## Changes to proposed District Map Amendment G-956

A revised version of DMA G-956, dated April 18, 2014, has been posted on the Planning Department website for review. It contains all of the proposed and approved changes that have occurred since March 7, 2014. The following document illustrates all of the changes to DMA G-956.

Changes made to DMA G-956 are organized into two sections, each section describing a different type of revision.

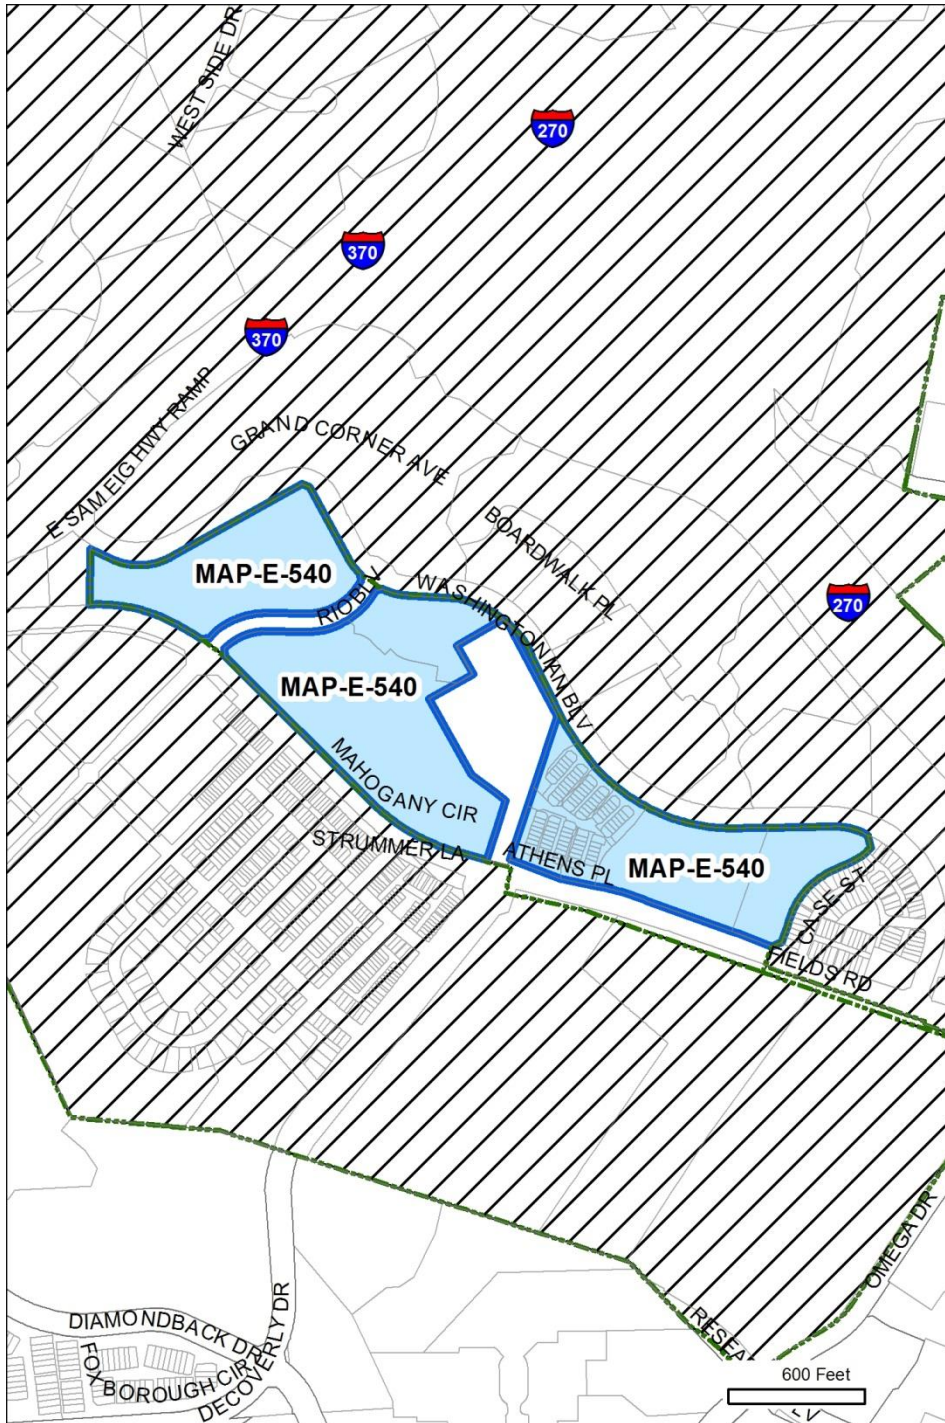
Unique ID: MAP-E-538		staff error
Master Plan ID: GRMTC-12B		
Master Plan:	Germantown Town Center	
Location:		
Existing Zone:	TMX-2	
Proposed Conv: (3/7)	<del>CR-1.0 C-0.75 R-0.75 H-60 T</del>	
Prop. Revised Conv:	CR-1.0 C-0.75 R-0.5 H-60 T	
Category:	Error	
Modifications	Zone Group:	No change
	Overall FAR:	No change
	Comm'l FAR:	No change
	Resid'l FAR:	Reduced to 0.5
	Height:	No change
<b>Reason for change:</b>		
<i>This property is zoned TMX-2. The Master Plan recommends a maximum residential development of 40%, and therefore, the residential FAR should be limited to 0.5.</i>		
<i>The proposed conversion to 0.75 FAR was made in error.</i>

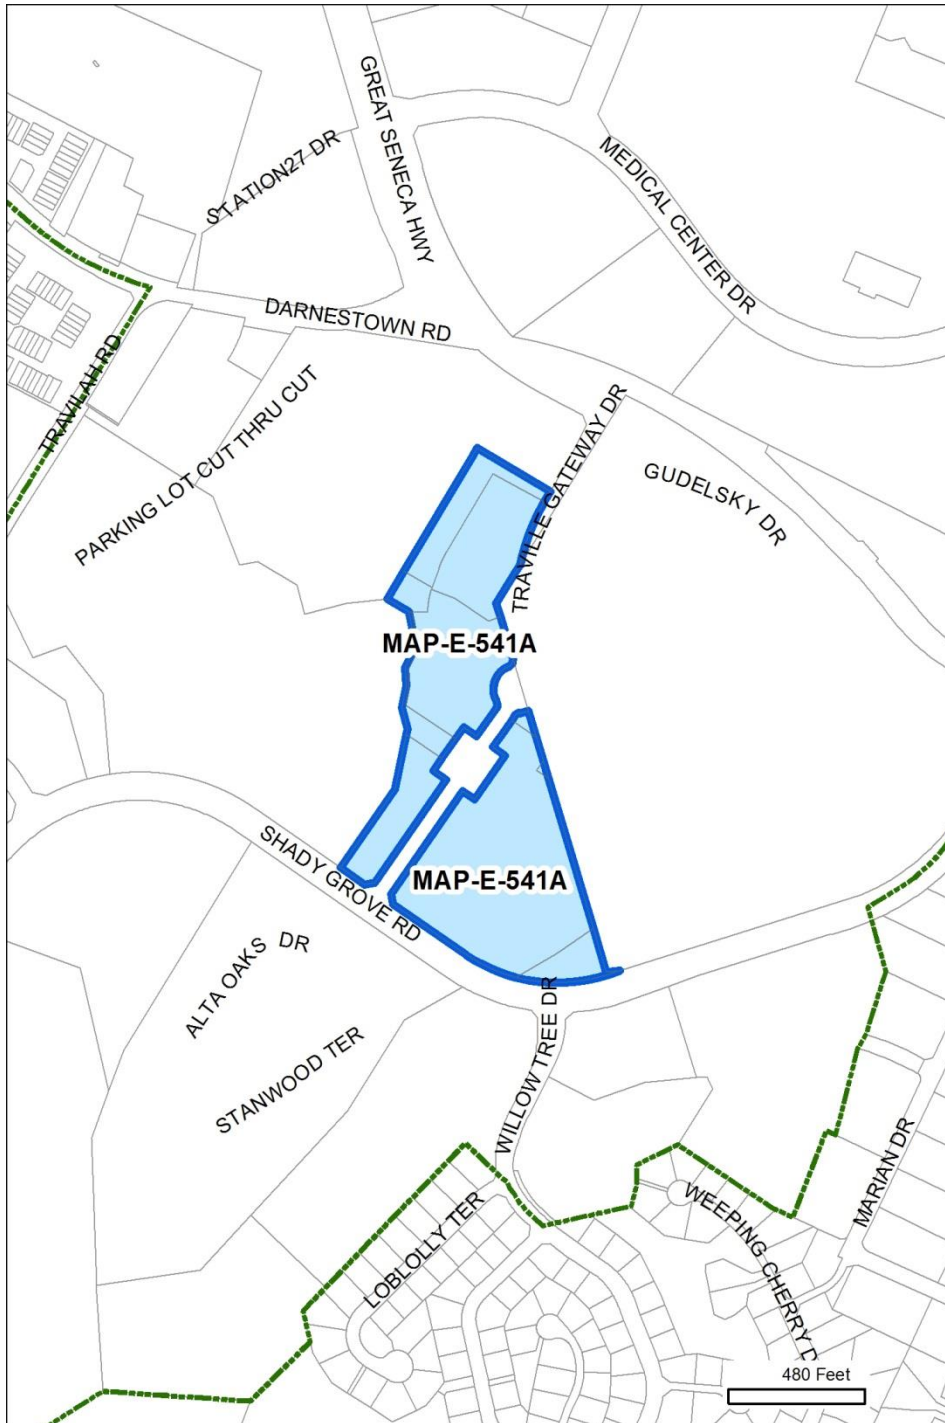
Unique ID: MAP-E-540		staff error
Master Plan ID: GSSCR-06		
Master Plan:		Great Seneca Science Corridor
Location:		
Existing Zone:		MXPD
Proposed Conv: (3/7)		CR-1.0 C-0.75 R-1.0 H-100 T
Prop. Revised Conv:		CR-1.0 C-0.25 R-1.0 H-110 T
Category:		Error
Modifications	Zone Group:	No change
	Overall FAR:	No change
	Comm'l FAR:	Reduced to 0.25
	Resid'l FAR:	No change
	Height:	Increased to 110'
Reason for change:		
<p><i>This property is zoned MXPD, which is a floating zone. Staff was instructed to zone based on the approved plans.</i></p> <p><i>In this case, the site is approved for minimal commercial development, and staff erroneously gave the "standard" conversion in terms of commercial FAR.</i></p> <p><i>The site should instead have a commercial FAR of 0.25.</i></p> <p><i>Additionally, the LMA G-439 permits heights on the site up to 10 stories.</i></p> <p><i>The site is subject to plans:</i></p> <p><b>819940040</b></p> <p><b>819930180</b></p> <p><b>819970150</b></p>

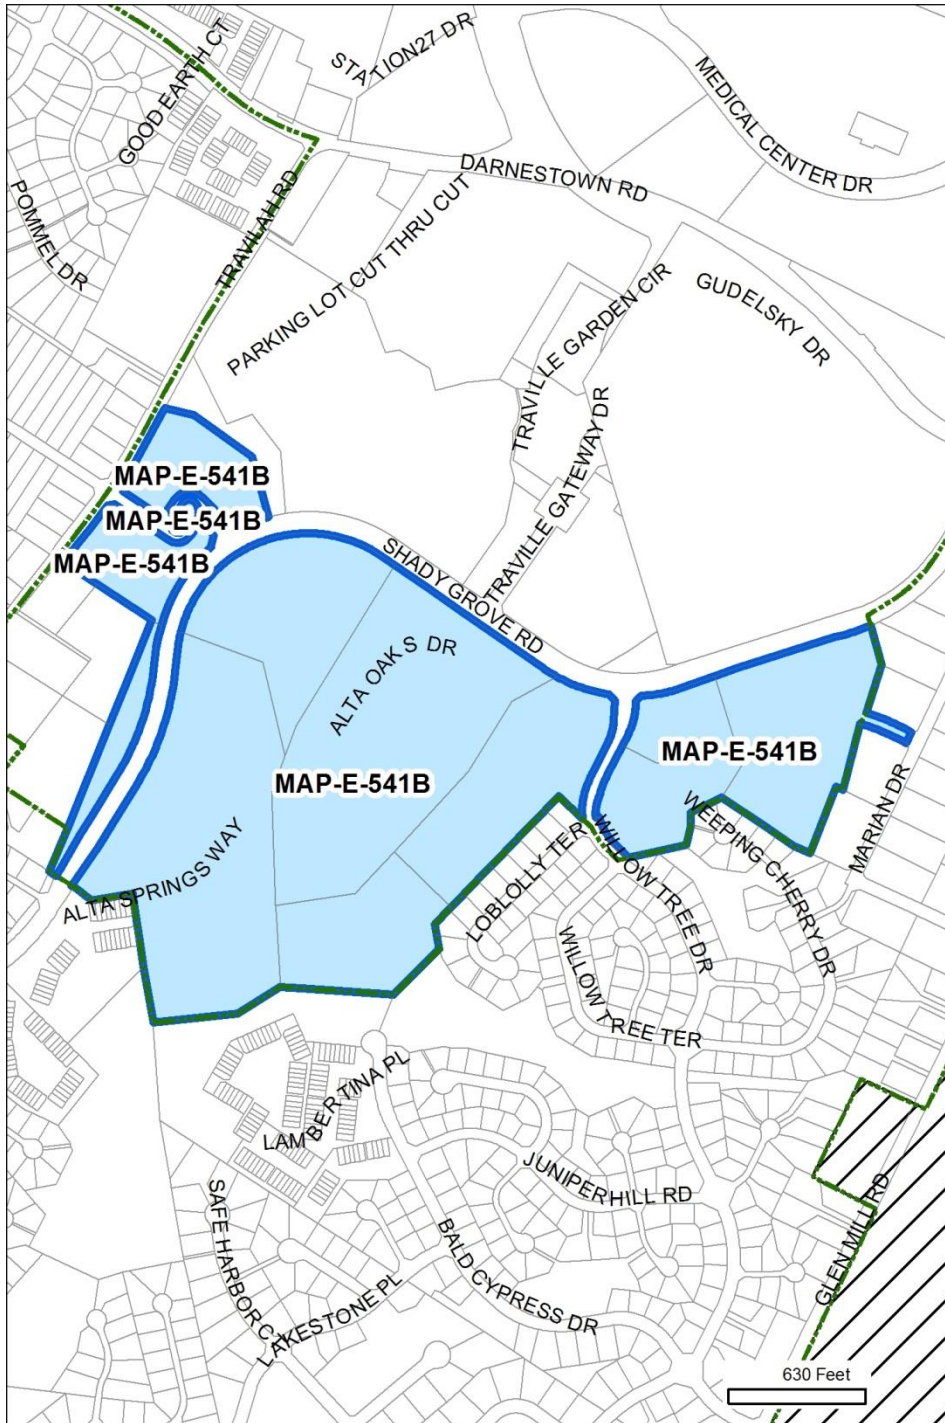
Unique ID: MAP-E-541A		staff error
Master Plan ID: GSSCR-05B		
Master Plan:	Great Seneca Science Corridor	
Location:		
Existing Zone:	MXN	
Proposed Conv: (3/7)	CRT-0.5 C-0.5 R-0.25 H-100 T	
Prop. Revised Conv:	CRT-0.5 C-0.25 R-0.25 H-70 T	
Category:	Error	
Modifications	Zone Group:	No change
	Overall FAR:	No change
	Comm'l FAR:	Reduced to 0.25
	Resid'l FAR:	No change
	Height:	Reduced to 70'
<b>Reason for change:</b>		
<p><i>This property is zoned MXN, which allows up to 0.3 FAR, with a minimum residential component of 25%.</i></p> <p><i>The adjacent property was approved for commercial FAR above 0.25, and the owner requested that the DMA be changed to reflect the amount of commercial for which the site was approved.</i></p> <p><i>Staff inadvertently, however, included adjacent properties which were not approved for greater commercial density. As a result, these properties should have received the "standard" conversion.</i></p> <p><i>The height should be 70', since the tallest building approved in this floating zone is 6 stories.</i></p>

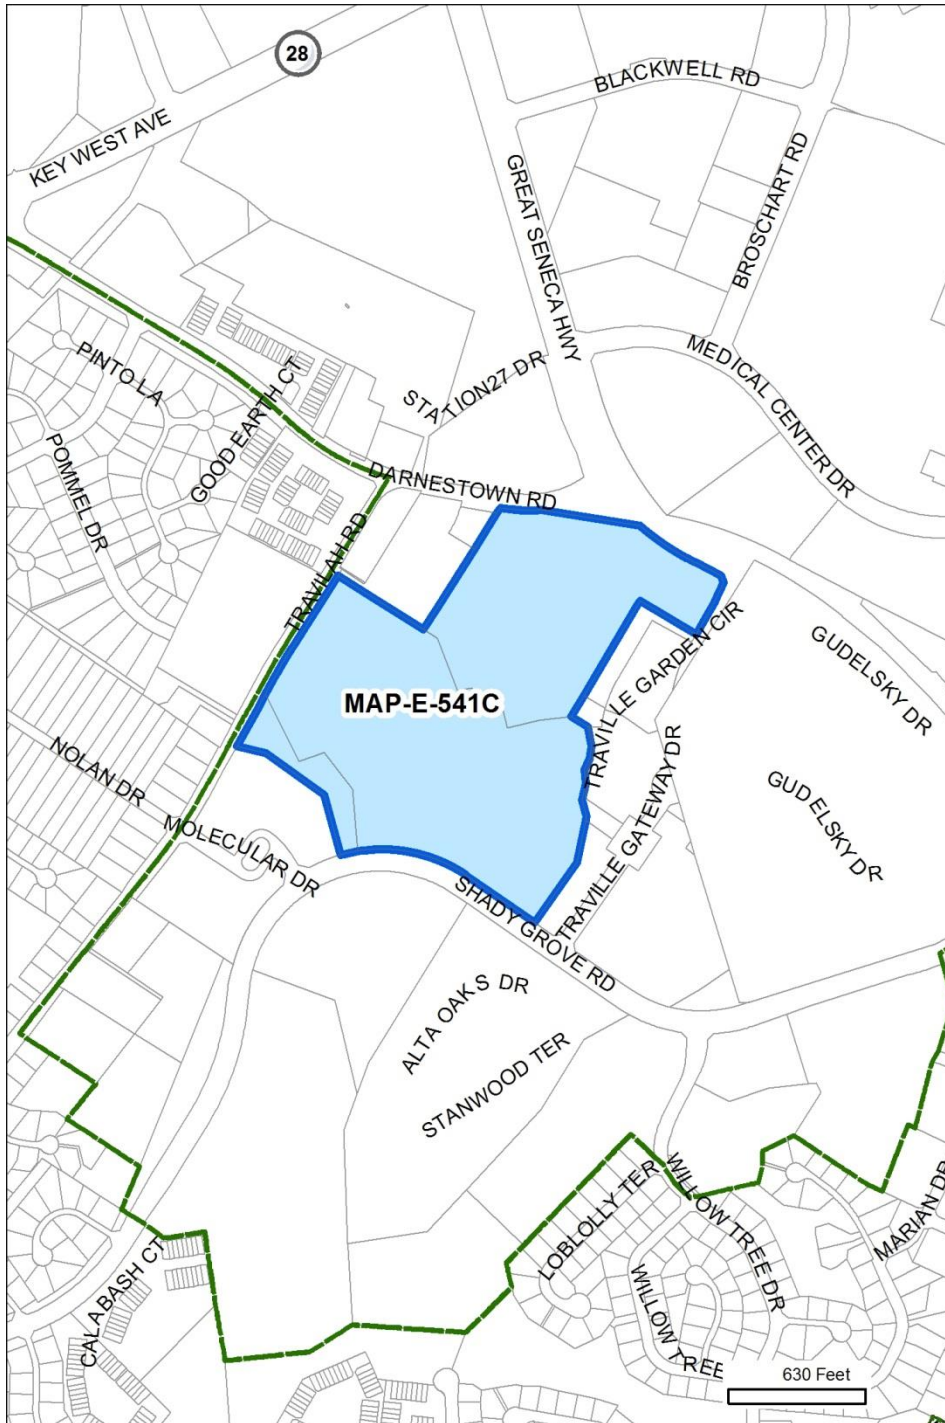
Unique ID: MAP-E-541B		staff error
Master Plan ID: GSSCR-05B		
Master Plan:	Great Seneca Science Corridor	
Location:		
Existing Zone:	MXN	
Proposed Conv: (3/7)	CRT-0.5 C-0.25 R-0.25 H-100 T	
Prop. Revised Conv:	CRT-0.5 C-0.25 R-0.25 H-70 T	
Category:	Error	
Modifications	Zone Group:	No change
	Overall FAR:	No change
	Comm'l FAR:	No change
	Resid'l FAR:	No change
	Height:	Reduced to 70'
<b>Reason for change:</b>		
<i>The height should be 70', since the tallest building approved in this floating zone is 6 stories. (There is no statutory height in this zone).</i>

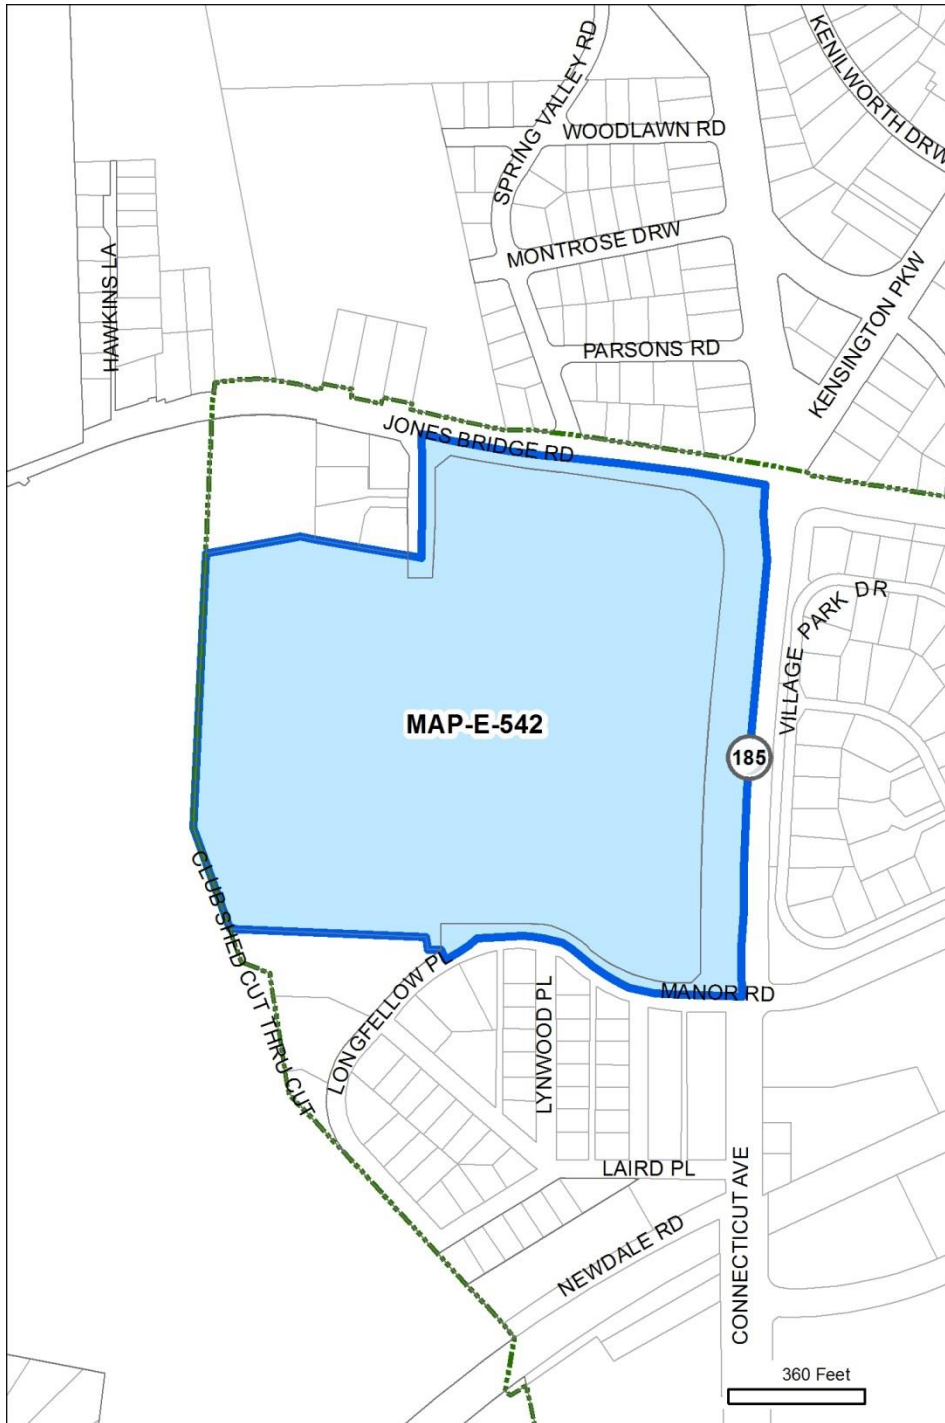
Unique ID: MAP-E-541C		staff error
Master Plan ID: GSSCR-05A		
Master Plan:	Great Seneca Science Corridor	
Location:		
Existing Zone:	MXN	
Proposed Conv: (3/7)	<del>CRT-0.5 C-0.5 R-0.25 H-100 T</del>	
Prop. Revised Conv:	CRT-0.5 C-0.5 R-0.25 H-70 T	
Category:	Error	
Modifications	Zone Group:	No change
	Overall FAR:	No change
	Comm'l FAR:	No change
	Resid'l FAR:	No change
	Height:	Reduced to 70'
<b>Reason for change:</b>		
<i>The height should be 70', since the tallest building approved in this floating zone is 6 stories. (There is no statutory height in this zone).</i>

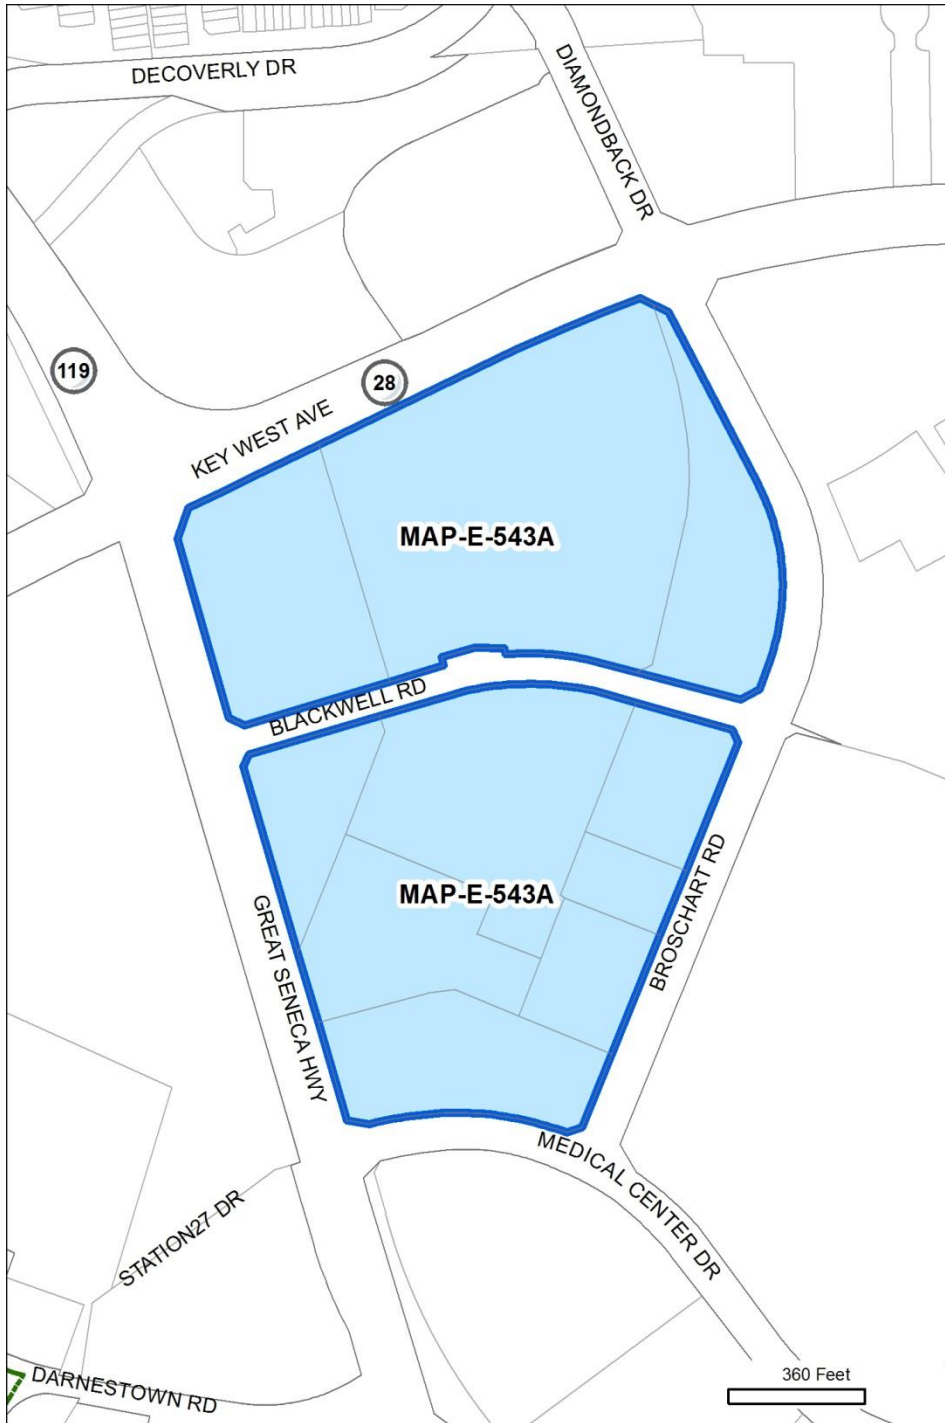
<b>Unique ID:</b> MAP-E-542		staff error
<b>Master Plan ID:</b> CCLKE-01		
<b>Master Plan:</b>	Chevy Chase Lake	
<b>Location:</b>		
<b>Existing Zone:</b>	LSC	
<b>Proposed Conv:</b> (3/7)	LSC-0.5 H-65	
<b>Prop. Revised Conv:</b>	LSC-0.5 H-65 T	
<b>Category:</b>	Error	
<b>Modifications</b>	<b>Zone Group:</b>	No change
	<b>Overall FAR:</b>	No change
	<b>Comm'l FAR:</b>	No change
	<b>Resid'l FAR:</b>	No change
	<b>Height:</b>	No change
<b>Reason for change:</b>		
<p><i>The LSC zone allows bonus density for the provision of additional MPDUs under Chapter 25A.</i></p> <p><i>This zone should have been given the "T" at the end of the formula to indicate that it is eligible for the MPDU density bonus.</i></p>

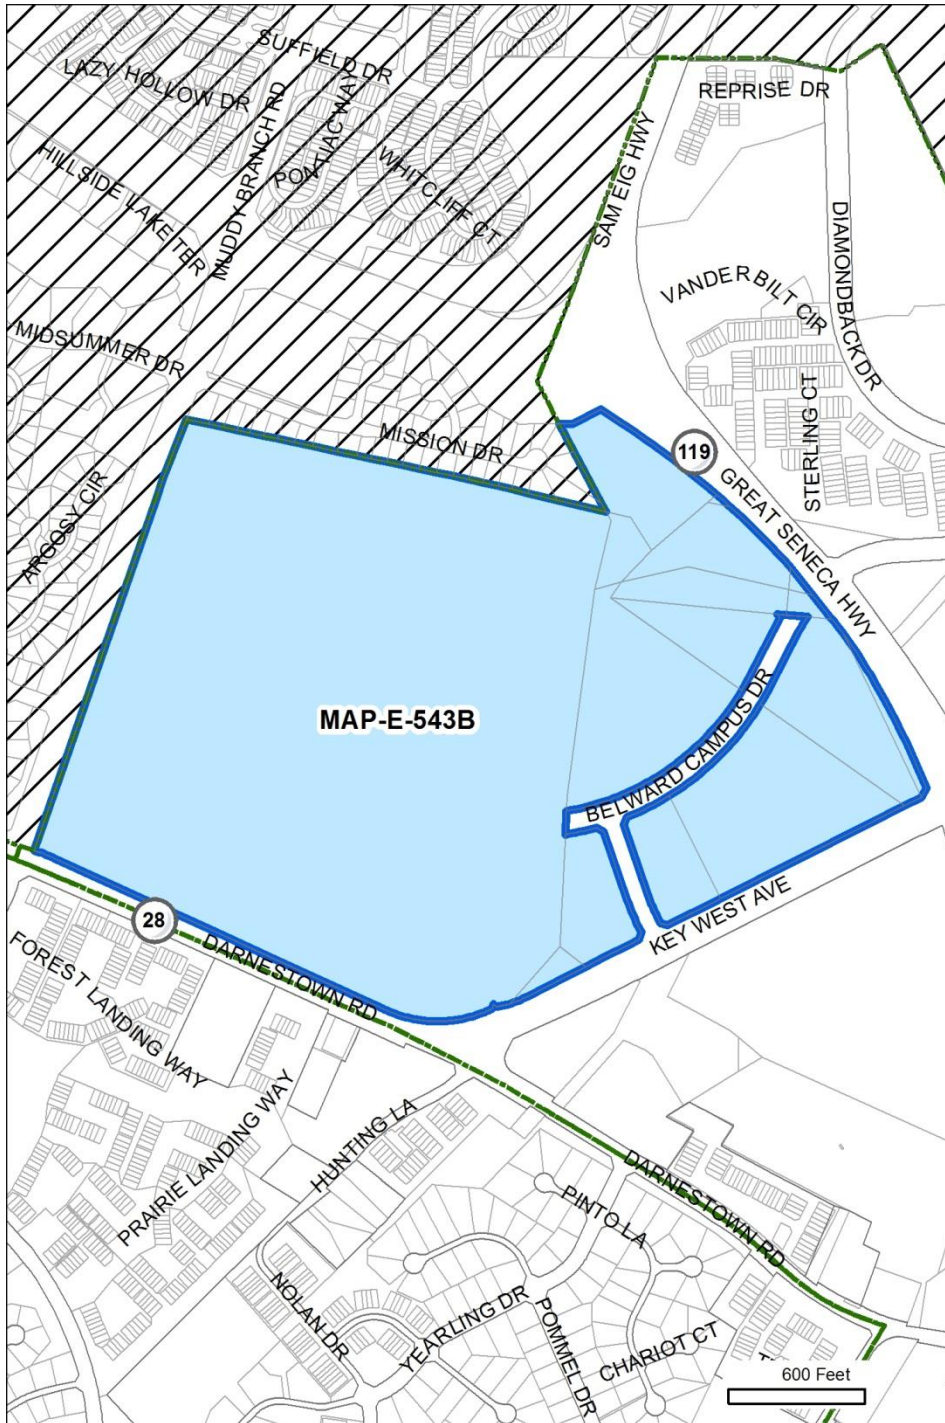
Unique ID: MAP-E-543A		staff error
Master Plan ID: GSSCR-01		
Master Plan:		Great Seneca Science Corridor
Location:		
Existing Zone:		LSC
Proposed Conv: (3/7)		LSC-1.0 H-150
Prop. Revised Conv:		LSC-1.0 H-150 T
Category:		Error
Modifications	Zone Group:	No change
	Overall FAR:	No change
	Comm'l FAR:	No change
	Resid'l FAR:	No change
	Height:	No change
Reason for change:		
<p><i>The LSC zone allows bonus density for the provision of additional MPDUs under Chapter 25A.</i></p> <p><i>This zone should have been given the "T" at the end of the formula to indicate that it is eligible for the MPDU density bonus.</i></p>
